UNITED STATES PATENT AND TRADEMARK OFFICE

APPLICATION NO.	FILING DATE	FIRST NAMED INVENTOR	ATTORNEY DOCKET NO.	CONFIRMATION NO.
10/670,538	09/25/2003	Mohan Gurunathan	10021209-1	5460

Office Action Summary

F I G. 2

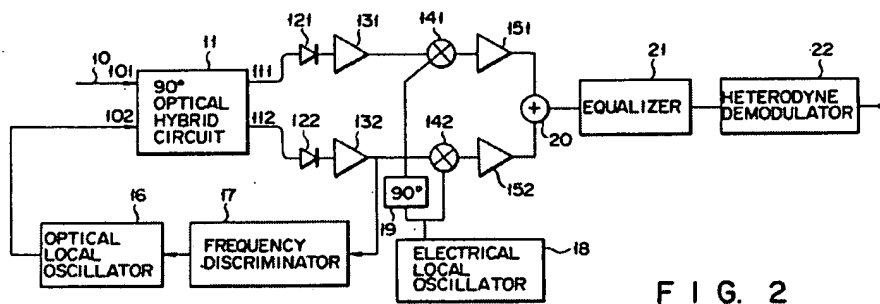
With regards to claims 1, 7, and 18, Okoshi et al. (Okoshi hereinafter) show a double stage phase diversity receiver comprising:

an optical hybrid (11) for combining said optical signal and an optical local oscillator signal to generate phase-diverse components;

a plurality of photodiodes (121, 122) with each photodetector illuminated by a respective one of said phase-diverse components thereby mixing said optical signal and said optical local oscillator;

a plurality of mixers (141, 142) for mixing said filtered signals from said plurality of bandpass filters with an electrical LO signal; and

a signal processing module (22) that determines said spectral content utilizing signals from said plurality of mixers.

Okoshi does not expressly show the filters.

van Deventer et al. (van Deventer hereinafter) show an optical hybrid having a plurality of amplifiers, instead of a plurality of bandpass filters, having the equivalent function to suppress

noise. Since the functions are equivalent, it would have been a matter of design choice to one of ordinary skill in the art to use a bandpass filter for lower cost.
